UNITED STATES PATENT AND TRADEMARK OFFICE

10/585,439

Office Action Summary	Application No. 10/585,439	Applicant(s) CLASEN ET AL.	
	Examiner YOGESH PATEL	Art Unit 3776

DETAILED ACTION

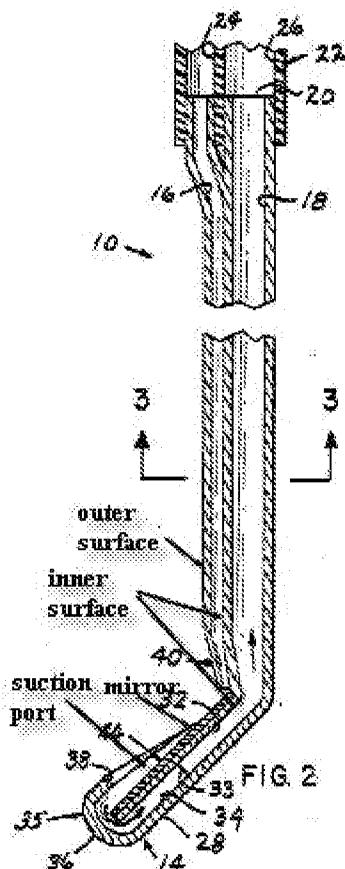
Claims 1, 2, 4, 5 are rejected under 35 U.S.C. 102(b) as being anticipated by Warriner (3,092,910).

Warriner discloses a dental suction apparatus (figures 1-5) having a hollow base body (e.g. 10) with a longitudinal axis X-X that comprises an outer surface (shown above), an inner surface (shown above) and a suction port (shown above), wherein a mirrored surface (shown above) is disposed in the region on the inner surface of the body. Please note that no suction or vacuum pump is attached to dental suction apparatus of claim 1 to perform any suctioning function.

Regarding claim 2, the inner surface has the mirrored surface (e.g. 44) that is viewable through the suction port, the suction port being configured to be at an incline (figure 2; col. 2, lines 21-23) with respect to the longitudinal axis X-X that the area of the suction port exceeds a cross-sectional area of the base body extending across the longitudinal axis.

Regarding claim 4, the mirror surface is disposed on a pluggable element (e.g. ring 54) that is releasably connected to the suction apparatus (col. 2, lines 60-65).

Regarding claim 5 a groove (e.g. recess 52) for insertion of the pluggable element is disposed in the region of the suction port (col. 2, lines 60-65).
